Access Compliance Report

Public Rights-of-Way

(Curb Ramps)

Intersection ID: 29671	Main Street: BANNINGTON_RD	Cross Street: TOM_CASTAIN_LN	Location: S
ADA ID: DA3471527054	Ramp Type: BlendTrans1	Initial Pass/Fail: Fail	Overall Compliance: No
Severity Score: 8.75			
Codes/Mitigation Info/Possible Solution		Field Measurements/Component Compliance

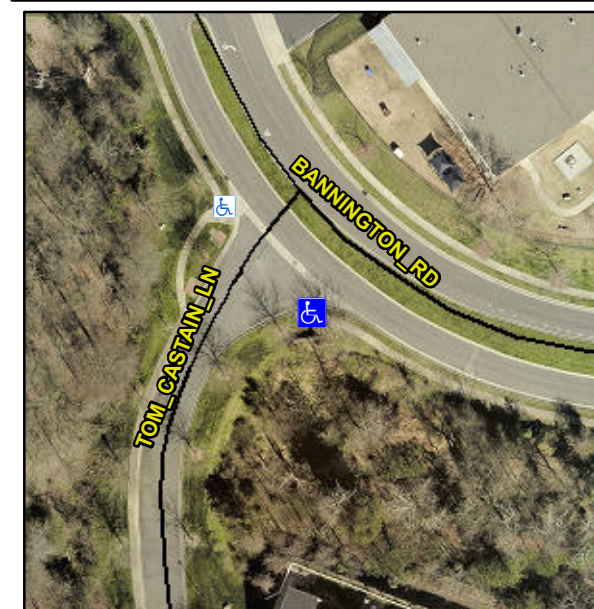
R304.5.1

Compliance	Description	Data	Compliance	Description	Data
N/A	Ramp Length (in)	45.0	Yes	BlendTrans Slope (%)	1.0
No	Ramp Width (in)	45.0	Yes	BlendTrans XSlope (%)	1.4
N/A	Flare Type LT	N/A	N/A	Flare Type RT	N/A
N/A	Flare Slope LT (%)	N/A	N/A	Flare Slope RT (%)	N/A
N/A	Flare Traversable LT?	N/A	N/A	Flare Traversable RT?	N/A
N/A	Landing Length (in)	N/A	N/A	DWS Provided?	N/A
N/A	Landing Width (in)	N/A	N/A	DWS Contrast?	N/A
N/A	Landing Slope (%)	N/A	N/A	DWS Length (in)	N/A
N/A	Landing X Slope (%)	N/A	N/A	DWS Full Width?	N/A
N/A	Landing Curb? (Y/N)	N/A	N/A	DWS Offset (in)	N/A
N/A	Shared Landing?	N/A			
N/A	Gutter Ponding?	N/A	N/A	Gutter Slope (%)	N/A
N/A	Gutter Lip Ht (in)	N/A	N/A	Gutter X Slope (%)	N/A
N/A	Painted X Walk1?	No	N/A	Painted X Walk2?	N/A
	X Walk 1 Direction	To NW		X Walk 2 Direction	N/A
	X Walk 1 Width (in)	N/A		X Walk 2 Width (in)	N/A
	X Walk 1 Slope (%)	4.3		X Walk 2 Slope (%)	N/A
	X Walk 1 X Slope (%)	0.4		X Walk 2 X Slope (%)	N/A

N/A	Ramp inside XWalk1?	N/A	N/A	Ramp inside XWalk2?	N/A
	Road Slope (%)	0.4		Clear Space?	N/A
	Road X Slope (%)	4.3	N/A	Clear Space to XWalk (in)	N/A
N/A	Any Obstructions?	N/A	N/A	Storm Grate/Utility Hazard?	N/A
	Obstruction Type			Storm Grate/Utility Type	
		N/A			N/A
			Yes	Surface Condition? (G/P)	Good
			N/A	Curb Slope (%)	2.7

Remove & Replace Curb Ramp With Two New Directional Ramps or Equivalent.
